Access Compliance Report

Public Rights-of-Way

(Curb Ramps)

Intersection ID: 13576	Main Street: WATSON_DR	Cross Street: WEST_BV	Location: NE
ADA ID: B3457DC07194	Ramp Type: PerpDiag	Initial Pass/Fail: Fail	Overall Compliance: No
Severity Score: 21.25			
Codes/Mitigation Info/Possible Solution		Field Measurements/Component Compliance

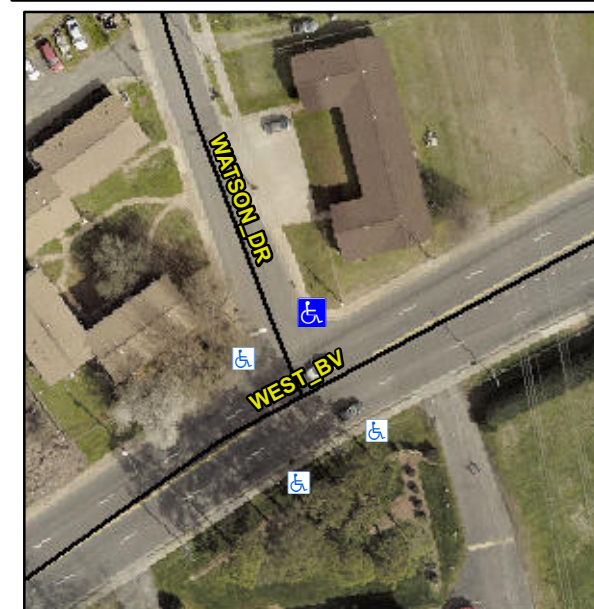
Not Found, R304.5.1, R304.5.3

Compliance	Description	Data	Compliance	Description	Data
N/A	Ramp Length (in)	48.0	Yes	Ramp Slope (%)	5.1
No	Ramp Width (in)	37.0	No	Ramp XSlope (%)	5.8
N/A	Flare Type LT	N/A	N/A	Flare Type RT	N/A
N/A	Flare Slope LT (%)	N/A	N/A	Flare Slope RT (%)	N/A
N/A	Flare Traversable LT?	N/A	N/A	Flare Traversable RT?	N/A
N/A	Landing Length (in)	N/A	N/A	DWS Provided?	N/A
N/A	Landing Width (in)	N/A	N/A	DWS Contrast?	N/A
N/A	Landing Slope (%)	N/A	N/A	DWS Length (in)	N/A
N/A	Landing X Slope (%)	N/A	N/A	DWS Full Width?	N/A
N/A	Landing Curb? (Y/N)	N/A	N/A	DWS Offset (in)	N/A
N/A	Shared Landing?	N/A			
N/A	Gutter Ponding?	N/A	N/A	Gutter Slope (%)	N/A
N/A	Gutter Lip Ht (in)	N/A	N/A	Gutter X Slope (%)	N/A
N/A	Painted X Walk1?	No	N/A	Painted X Walk2?	No
	X Walk 1 Direction	To W		X Walk 2 Direction	To SE
N/A	X Walk 1 Width (in)	N/A	N/A	X Walk 2 Width (in)	N/A
	X Walk 1 Slope (%)	1.9		X Walk 2 Slope (%)	2.9
	X Walk 1 X Slope (%)	1.4		X Walk 2 X Slope (%)	3.9

Remove & Replace Curb Ramp With Two New Directional Ramps or Equivalent.
